PRODUCT CHANGE NOTIFICATION (PCN)

AMJS1010-0050-BKB-26
MODULAR CABLE

CHANGE NOTIFICATION: PCN 20220425_AMJS1010-0050-BKB-26

DESCRIPTION OF CHANGES:
CHANGE OF DATA SHEET
CHANGE OF DATA SHEET
New Draw.-No. ASS_7943_CArev02

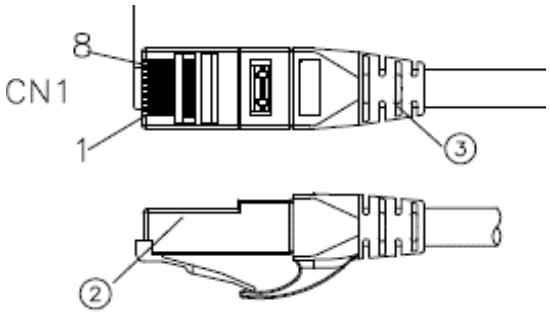
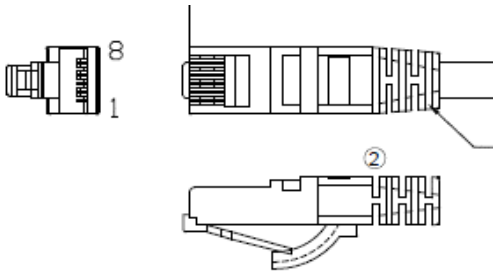
△4	AL-FOIL	Double-sided conductive aluminum foil ②	2	PCS
△3	Molding	LSOH 65P Color: see order code ②	NA	KG
△2	CONNECTOR	RJ45 8P8C two fork 3u" gold plated with metal shield	2	PCS
△1	CABLE	CAT6a S/FTP (26AWG*1PR+A)*4+B(AM)+LSOH OD=5.8±0.3MM Color: see order code ②	NA	MM
NO:	NAME	DESCRIPTION	Q'TY	UNIT

Drawing-No.
ASS 7943 CA

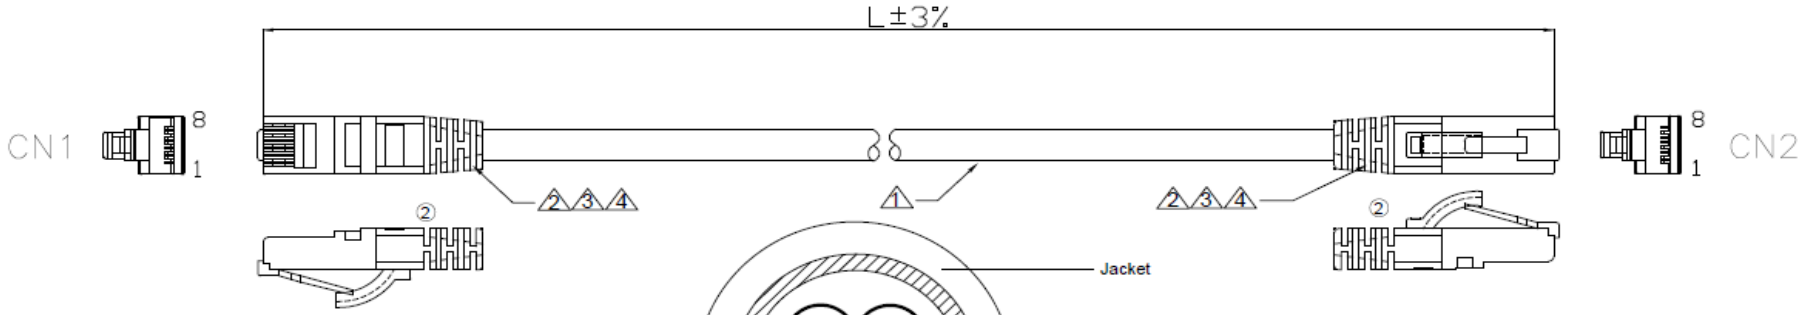
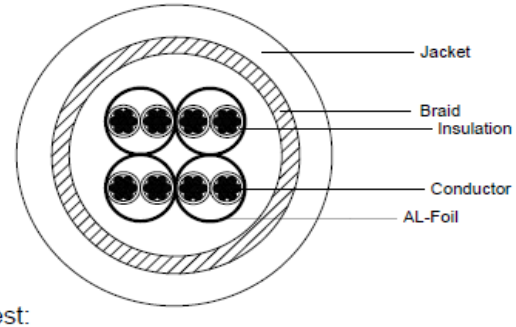
Id.	Modification	Date	Name
②	Change the plant	12.04.2022	Luca
①	Update the WSW order code	02.06.2017	Amy
⓪	Drawn	30.03.2017	Amy
